ISSUE DATE: 6/17/05

**ON-SITE SEWAGE DISPOSAL SYSTEM**  
**HOWARD COUNTY HEALTH DEPARTMENT**  
**BUREAU OF ENVIRONMENTAL HEALTH**

ADDRESS: 13401 Allnutt Lane PHONE NUMBER: 301-859-9994

NOT TO SCALE

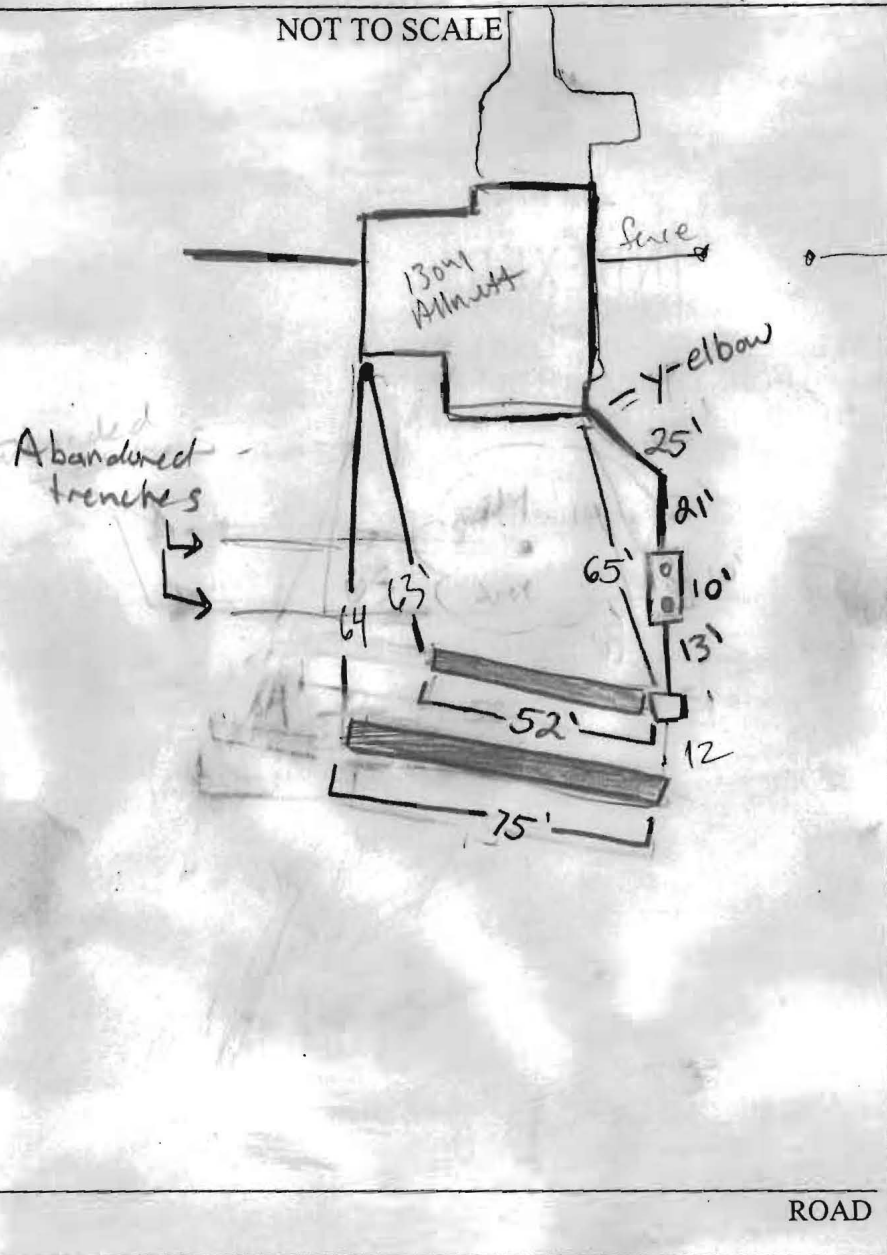
INSTALLATION Layout - 1 56' trench + 1 70' trench  
3' wide PAY 7/12/05 tank level 4 in place  
1st trench shorter than layout, but added to  
second trench for future pool installation.  
O.K. to cover all work (PAY)

# FILE INQUIRY FORM

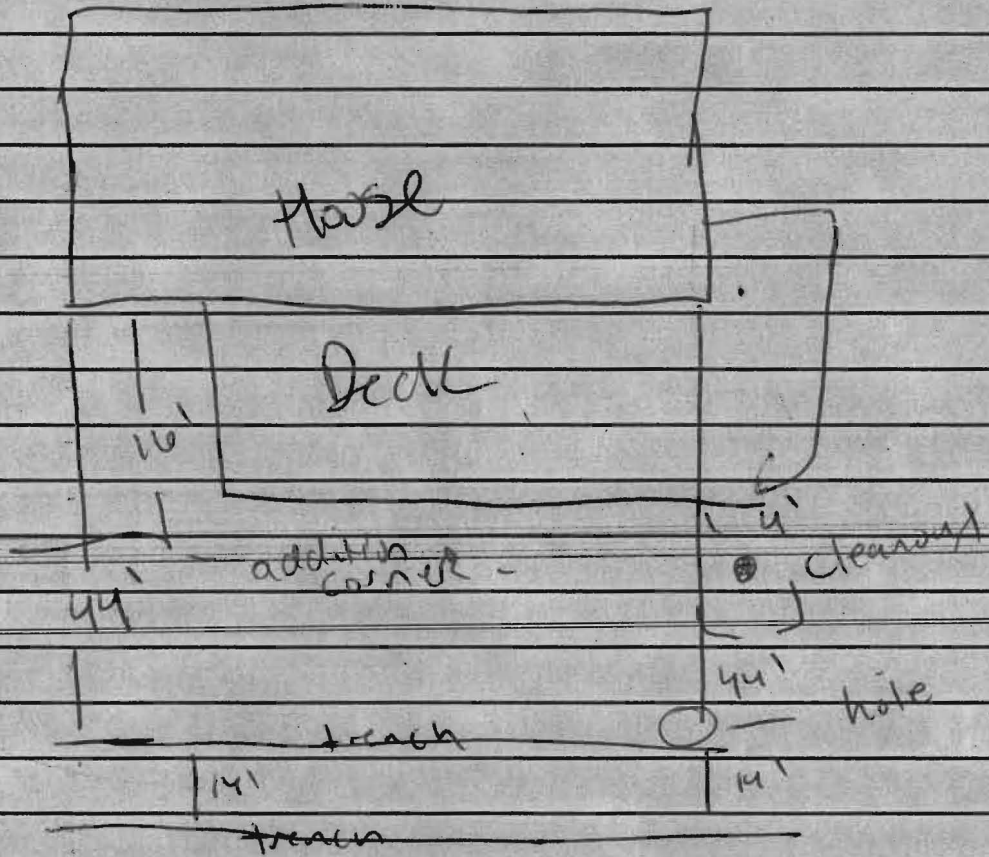
Need a  
1500  
gallon  
tank

~~Need plan~~  
Possible Pool

LOCATION DIAGRAM

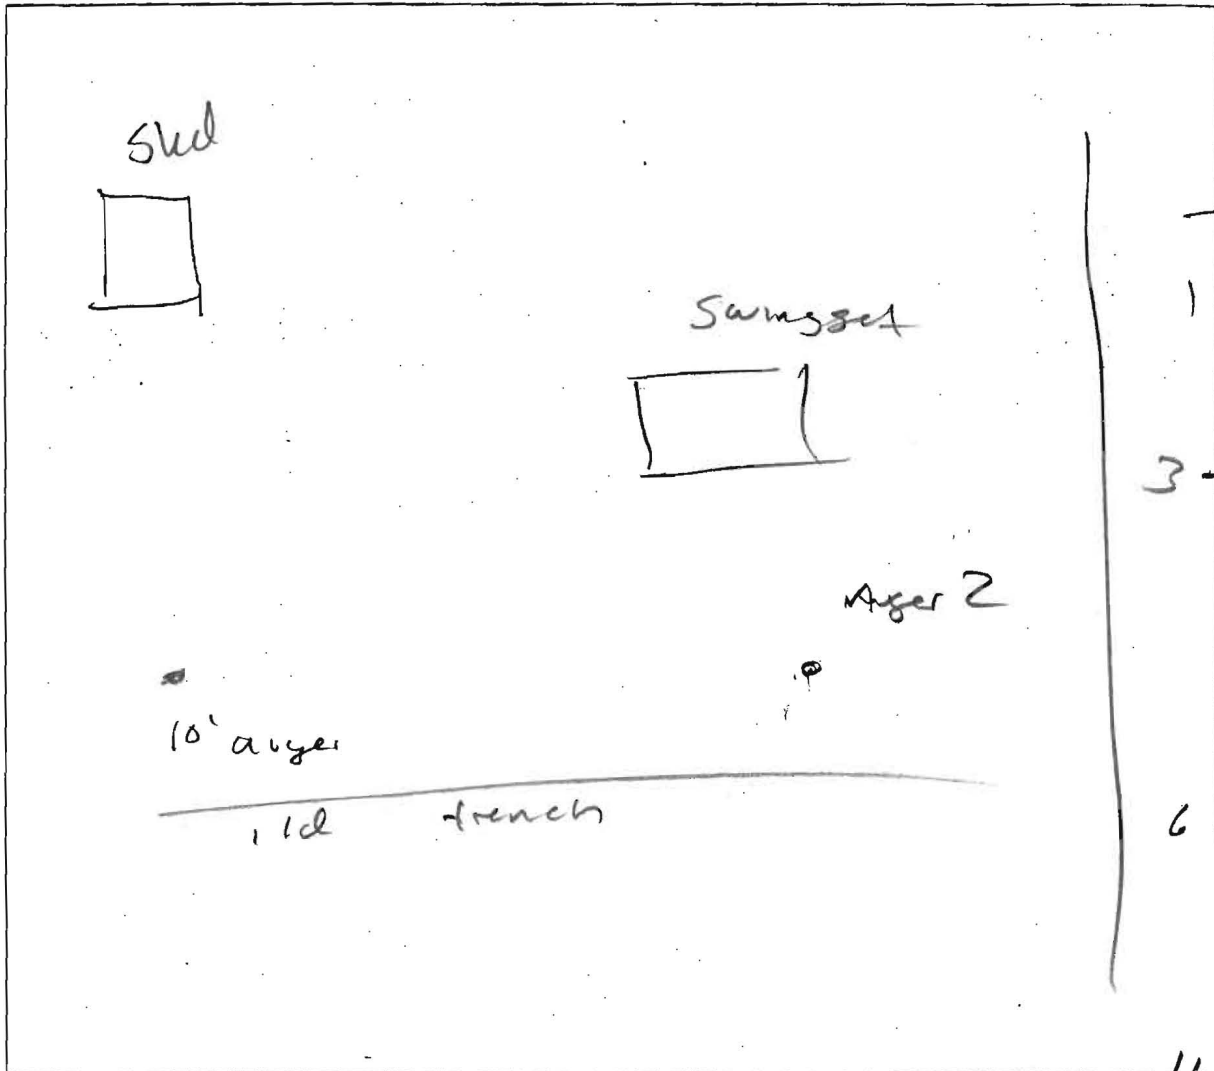
COMMENTS: Bottom at 6 inlet @ 3

3' Sidewall @ 180

GOOD SOILS
